Article No. 99-24-9

FORD: 1994-1997 PROBE
1995-2000 CONTOUR

MERCURY: 1995-2000 MYSTIQUE
1999-2000 COUGAR

This TSB article is being republished in its entirety to update the model year coverage, add a concern to the title, and revise the Service Procedure.

Figure 1 - Article 99-24-9

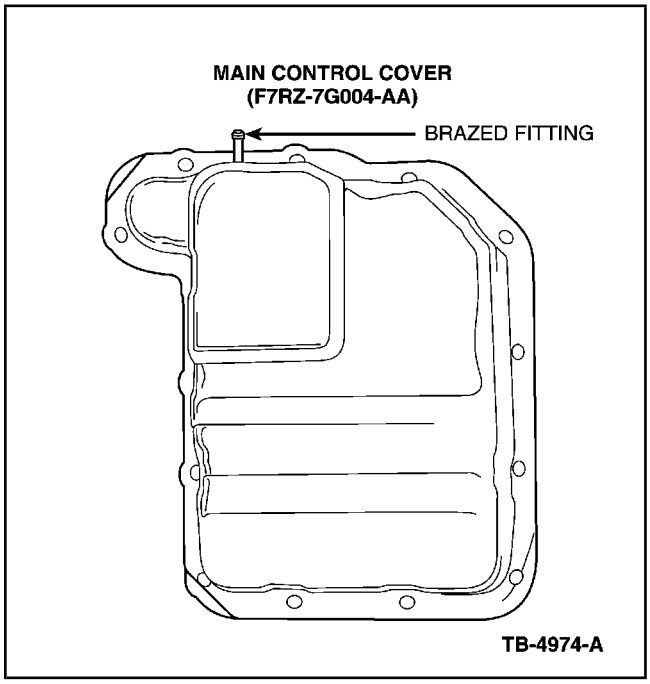
BEGINNING JANUARY 1997, ALL CD4E TRANSAXLES CONTAIN A REVISED MAIN CONTROL COVER (F7RZ-7G004-AA), FIGURE 1, AND VENT TUBE ASSEMBLY (F7RZ-7034-CA FOR PROBE AND F7RZ-7034-BA FOR CONTOUR/MYSTIQUE), FIGURE 2. THIS NEW DESIGN WILL PREVENT FLUID FROM SEEPING FROM THE VENT. IF THE VENT HOSE IS KINKED OR BLOCKED INTERNALLY, FLUID WILL LEAK FROM THE TRANSAXLE FILL TUBE.

Figure 3 - Article 99-24-9

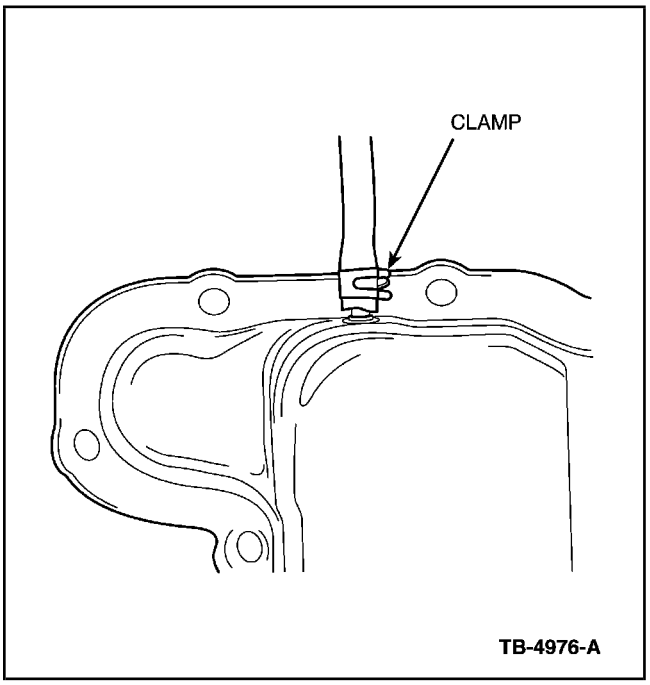
1. Fully seat straight end of tube onto brazed fitting on main control cover. Mount clamp securely onto brazed fitting to secure tube assembly (Figure 3).
2. Route tube assembly toward rear of vehicle.

1. Fully seat straight end of tube onto brazed fitting on main control cover. Mount clamp securely onto brazed fitting to secure tube assembly (Figure 3).
2. Route tube assembly upward toward the rear of the battery (Figure 5).
3. Attach clip to battery hold-down bracket bolt (Figure 6).
4. Be sure 90 degree tube end is routed downward (Figure 7).

Figure 4 - Article 99-24-9

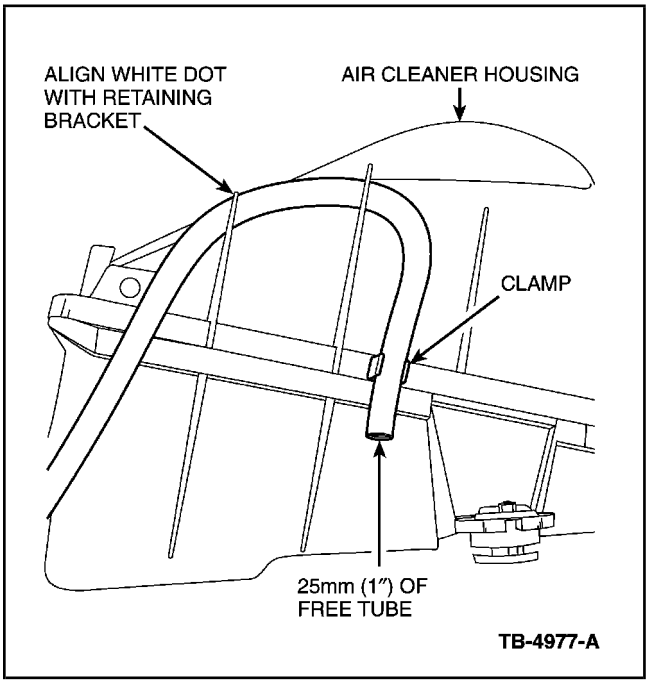
3. Install tube assembly on air cleaner housing and align white dot with retaining bracket closest to front of vehicle. Insert 90 degree elbow end of tube assembly into air cleaner clamp. Allow approximately 25mm (1″) of free tube (Figure 4).
